comment sheet		22 Mar 2011
	Marine Division		O. Mail Ref. :
	BV Reg. No : 17566V Project : ISV1		Hull No : H01
	Manufacturer/Supplier/Owner : Meridien Maritime Inc.

Hull – Drawings				
Drawing No	Rev.	Title	Approval stamp	Comment status
500-03-ISV2	0	ctd davit structure	1b

Hull - Comments on drawings		
Drawing number 500-03-ISV2 Rev 0	Mail ref. : sgirouard@meridien.cc> on 07 Feb 2011	
ctd davit structure	for review	Approval stamp : 1b

BMF Fleet Technology Ltd. 25 Hamworth Rd. SL, Ashby, LE Leicestershire LE19 1HT Tel: 01930-755-5880 Fax: 01930-755-5881 e-mail: info@bmft.co.uk http://www.bmft.co.uk	Title: CTD DAVIT STRUCTURE Drawing No.: 500:03 Rev.: 2 Sheet: 2 OF 2	Scale: 1:20 Dwg Size: A1
--	--	-----------------------------

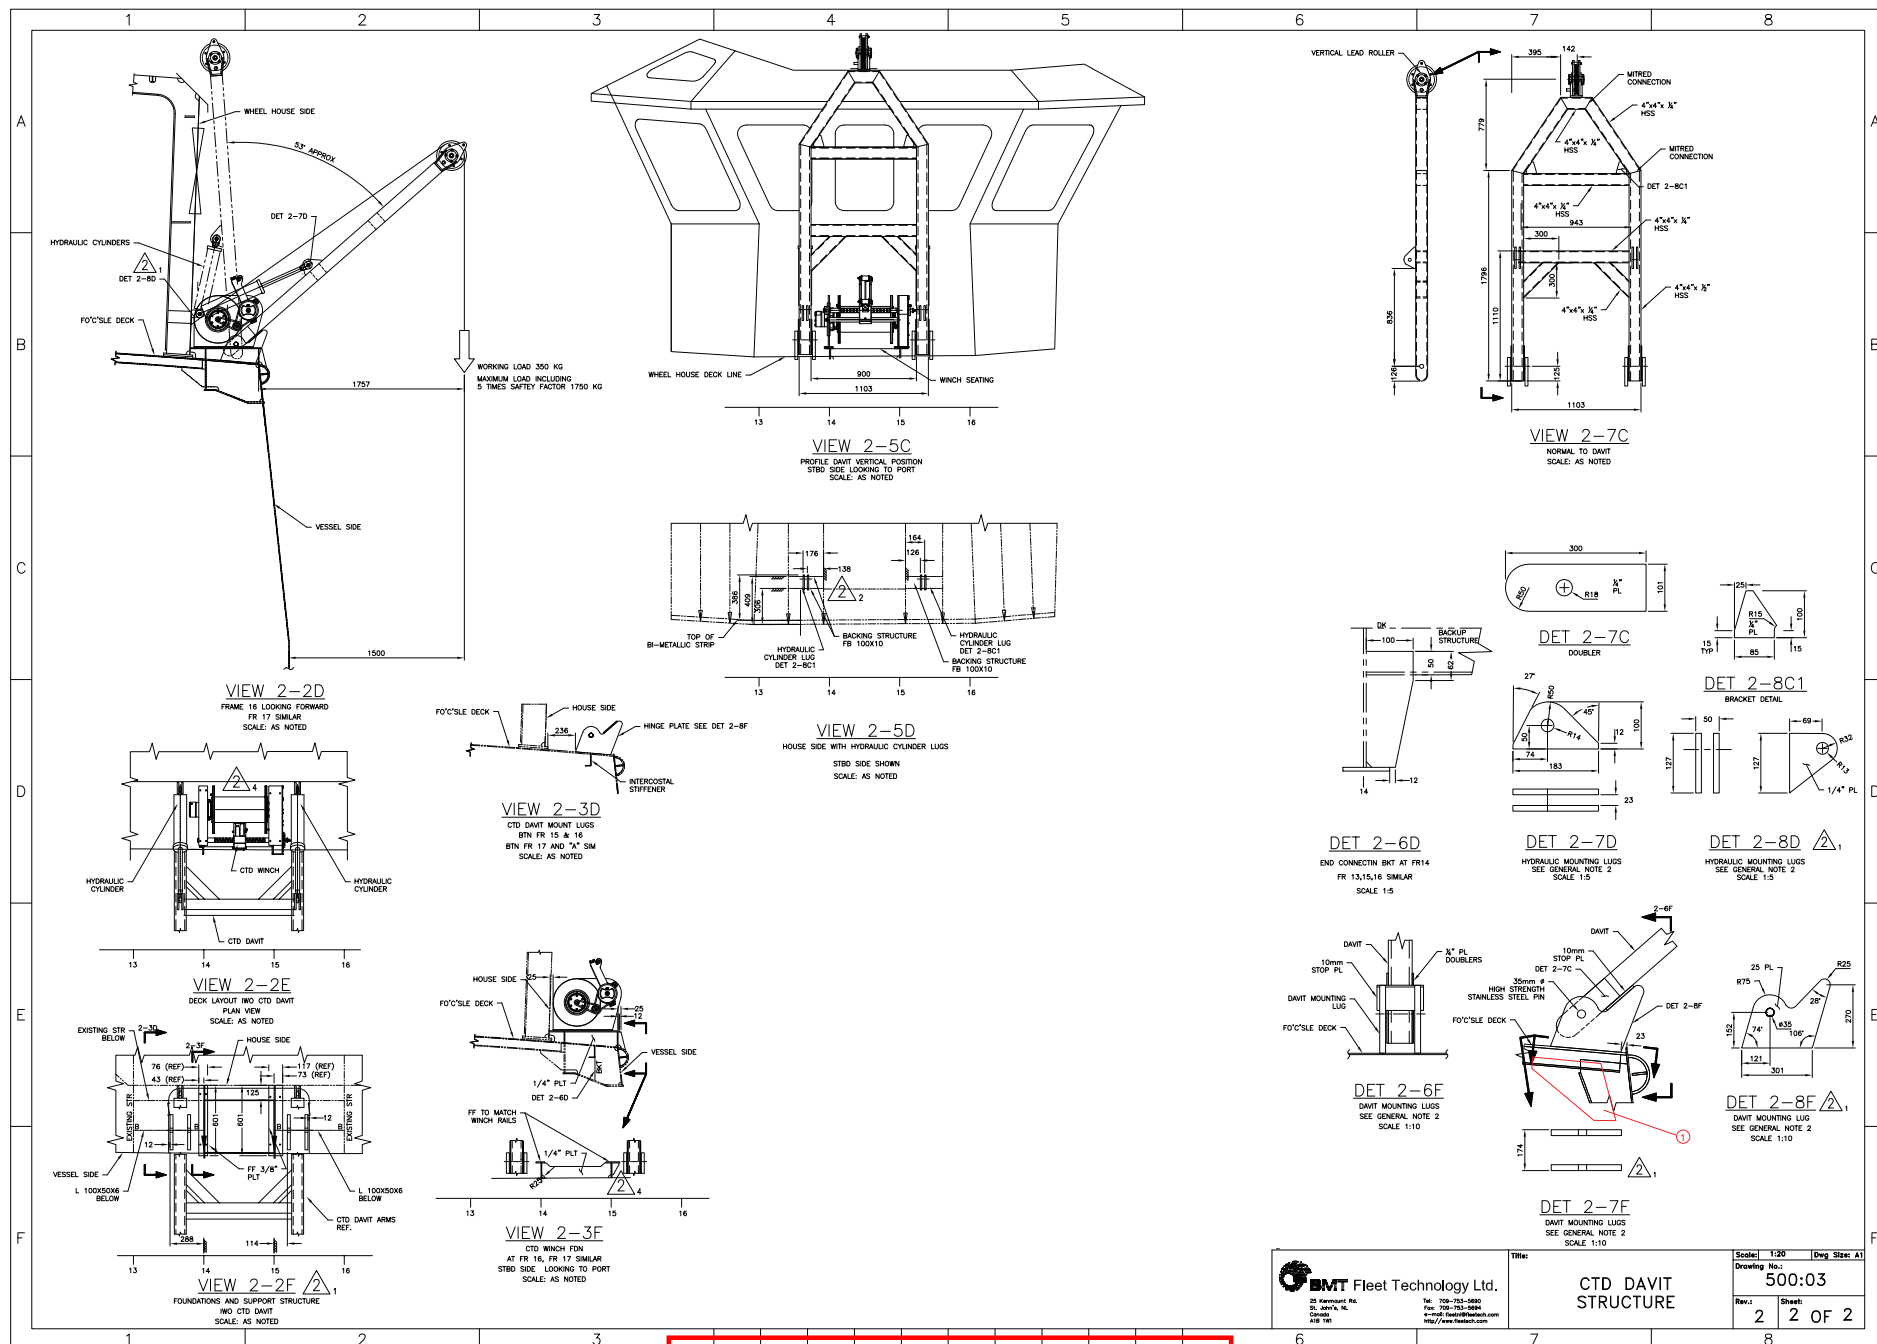
Davit reviewed according with BV Rules for Steel Ships. Not reviewed as Lifting Appliance or Life Saving Appliance.

Structure bellow main deck, in correspondence with davit hinges, to be reinforced by brackets, minimum dimensions: 300x300x8
